Type Coffee Vending Machine	Model 9XXX	N° T.I. 04 - 2022
Serial Number 20421345	Subject Z4000 upper piston filter plate improvement	ISSUED FOR (X) Action Information X

Picture 1

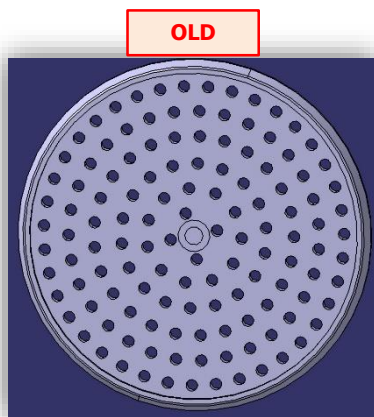
Ten extra studs (orange dots in the picture 3) on the Z4000 brewer upper piston base plate (filter support, part #5 in picture 1) have been implemented.
